UNITED STATES PATENT AND TRADEMARK OFFICE

APPLICATION NO.	FILING DATE	FIRST NAMED INVENTOR	ATTORNEY DOCKET NO.	CONFIRMATION NO.
10/767,835	01/29/2004	Arnd Reichert	2001P13904WOUS	8933

Office Action Summary	Application No.		Applicant(s)	
	10/767,835		REICHERT	
	Examiner		Art Unit	
	William H. Rodriguez		3746

DETAILED ACTION

FIG. 1

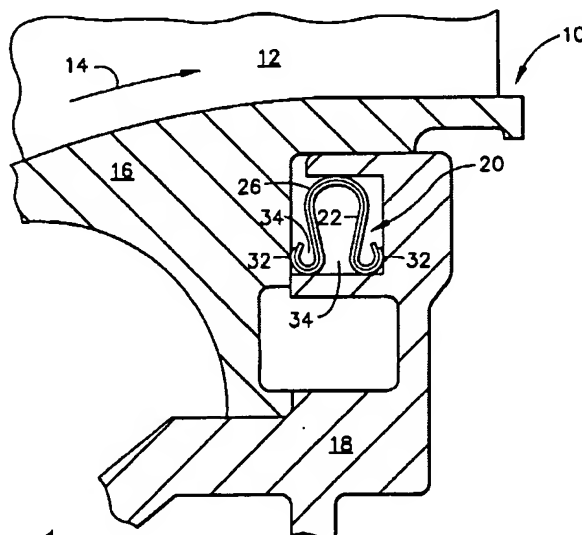
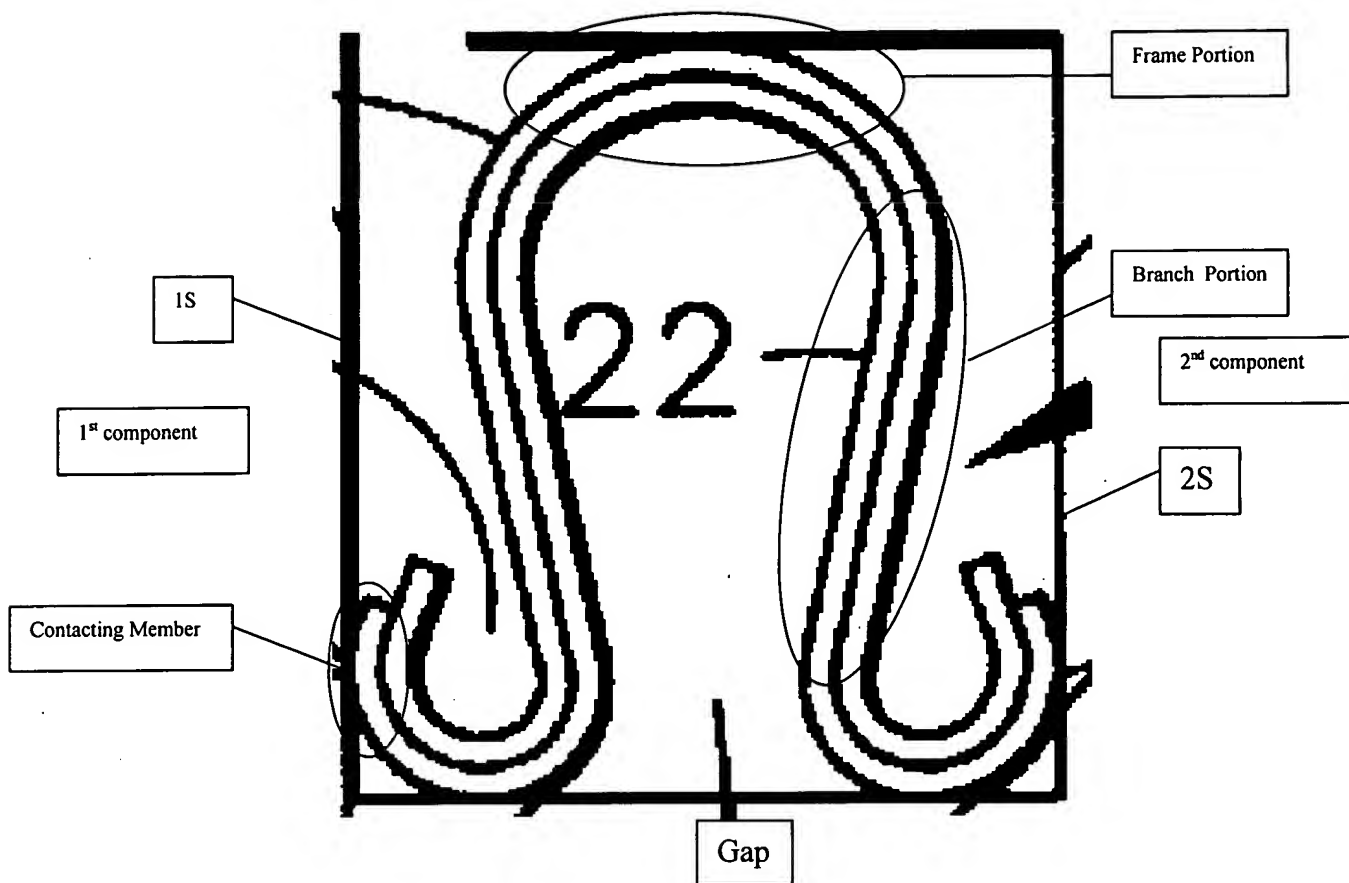
With respect to claim 1, **Liotta** teaches a seal element (20) for sealing a gap between a first component (16) and a second component (18) spaced apart from each other, said the first component having a first surface (1S) and the second component having an opposing second surface (2S), said seal element comprising: a support structure (22) having at least two contacting members and a sealing structure (26) covering at least partially said the support structure, wherein each contacting member serves for putting a portion of the sealing structure in contact with one of the surfaces, and being capable of following a movement of said surface and wherein the support structure has a frame portion to which the contacting members is connected via a branch portion extending away from the frame portion. See particularly **Figure 1** of **Liotta**.

With respect to claim 7, **Liotta** teaches that the sealing structure 26 is loosely connected to said support structure 22. See column 4 lines 5-9 of **Liotta**.

With respect to claim 8, **Liotta** teaches that the support structure 22 consists of a metal, in particular a sheet metal. See particularly **Figure 1** of **Liotta**.

With respect to claim 9, **Liotta** teaches that the support structure (22) has a curved form, in particular is U-shaped, open-ring shaped. See particularly **Figure 1** of **Liotta**.

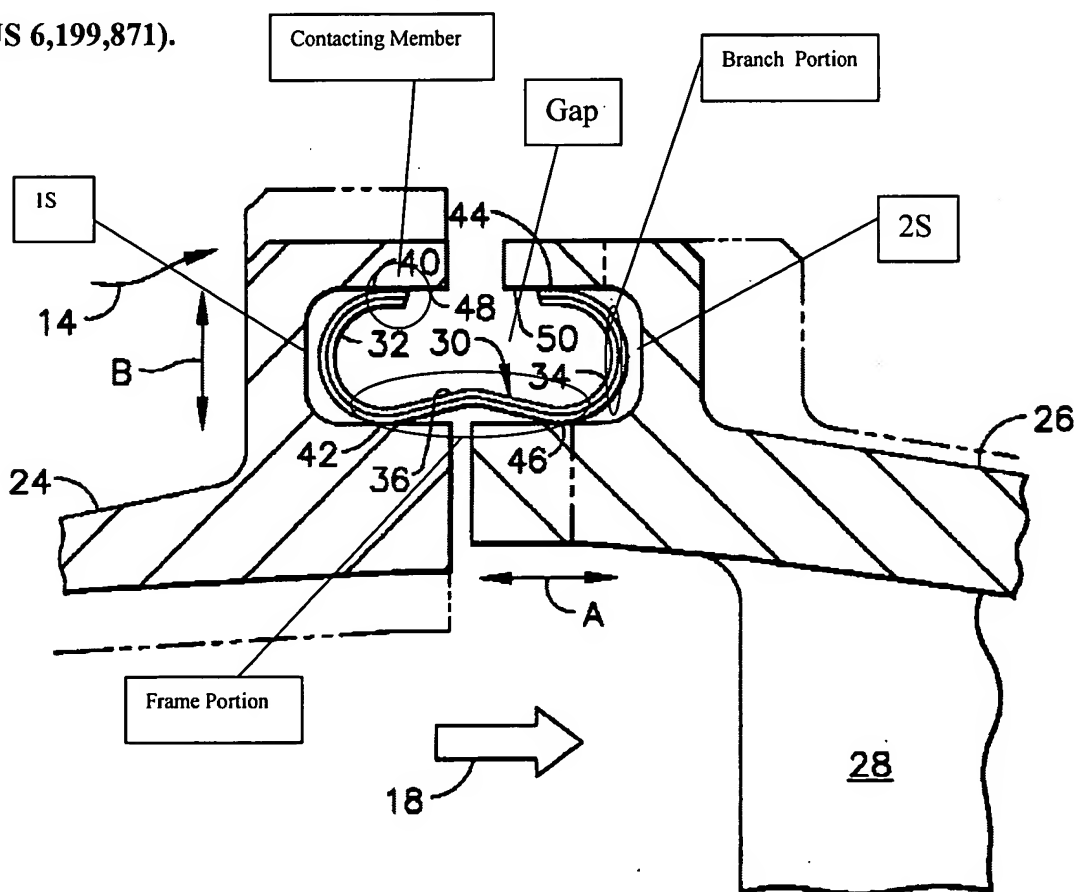
component having a first surface (1S) and the second component having an opposing second surface (2S), said seal element comprising: a support structure (34) having at least two contacting members and a sealing structure (32) covering at least partially said the support structure, wherein each contacting member serves for putting a portion of the sealing structure in contact with one of the surfaces, and being capable of following a movement of said surface and wherein the support structure has a frame portion to which the contacting members is connected via a branch portion extending away from the frame portion. See particularly **Figures 1, 3, 4** of **Lampes**.

With respect to claim 8, **Lampes** teaches that the support structure 34 consists of a metal, in particular a sheet metal. See particularly **Figures 1, 3, 4** of **Lampes**.

With respect to claim 9, **Lampes** teaches that the support structure (34) has a curved form, in particular is U-shaped, open-ring shaped. See particularly **Figure 4** of **Lampes**.

With respect to claim 10, **Lampes** teaches that the branch portion and said the contacting member are elastically deformable. See particularly **Figure 3** of **Lampes**.

With respect to claim 15, **Lampes** teaches that the seal element is for the use in a hot gas chamber 16 having a hot-gas flow region (18), said the hot gas chamber comprising: a wall structure (22) surrounding the hot-gas flow region and comprising the second component (26) having the second surface 2S, the first component (24) being attached to said wall structure (22) and having the first surface 1S, which is directed to the wall structure, wherein the gap is formed between the first component and the second component, the sealing structure being in contact with the second surfaces (2S) of the second component (26) and with the first surface (1S) thereby sealing the gap. See particularly **Figures 1, 3** of **Lampes**.

With respect to claim 16, **Lampes** teaches that the hot gas chamber is a part of a combustion turbine. See particularly **Figure 1** of Lampes.

With respect to claim 17, **Lampes** teaches that the first component (24) is a combustion chamber of a turbine section. See particularly **Figure 1** of Lampes

With respect to claim 18, **Lampes** teaches that the seal element is for the use in a combustion turbine, the combustion turbine comprising: a burner (shown but not labeled), a turbine section having a turbine inlet for hot gas to enter the turbine section, and a duct 22 connecting the burner to the turbine section for hot gas to flow from said burner to said turbine section, whereby the first surface 1S is formed by the turbine inlet and the second surface 2S by the duct (22) in the vicinity of the turbine inlet, with the gap between the first surface and the second surface sealed by the seal element. See particularly **Figures 1, 3** of Lampes.

With respect to claim 19, **Lampes** teaches a combustion turbine comprising: a hot gas chamber (16) having a hot-gas flow region, a wall structure (22) surrounding the hot-gas flow region and comprising at least one second component (26) having a second surface (2S) directed to the hot-gas flow region, at least one first component (24) being attached to the wall structure and having a first surface 1S which is directed to the wall structure, a gap formed between the first component (24) and the second component 26, a seal element (30) for sealing said gap, the seal element comprising: a support structure (34), a sealing structure (32) covering at least partially the support structure, wherein the support structure comprises at least two contacting members, each contacting member puts a portion of the sealing structure in contact with one of the surfaces, and being capable of following a deformation of the surface, wherein the support

structure has a frame portion to which the contacting members is connected via a branch portion extending away from said frame portion. See particularly **Figures 1, 3, 4** of Lampes.

With respect to claim 20, **Lampes** teaches a combustion turbine comprising: a burner (shown but not labeled), a turbine section having a turbine inlet for hot gas to enter the turbine section, a duct 22 connecting the burner to said turbine section for hot gas to flow from the burner to the turbine section, whereby a first surface 1S is formed by the turbine inlet (44) and a second surface 2S by the duct in the vicinity of the turbine inlet, so that a gap is formed between the first surface and the second surface, and a seal element 30 for sealing the gap, the seal element (30) comprises: a support structure 34, a sealing structure (32) covering at least partially the support structure, wherein the support structure comprises at least two contacting members, each contacting member puts a portion of the sealing structure in contact with one of the surfaces, and being capable of following a deformation of the surface, wherein the support structure has a frame portion to which the contacting members is connected via a branch portion extending away from said frame portion. See particularly **Figures 1, 3, 4** of Lampes.

With respect to claim 21, **Lampes** teaches that the seal element 30 comprises a curved frame portion from which the contacting members are spaced apart and each contacting member being connected to the frame portion via a branch portion. See particularly **Figure 3** of Lampes.
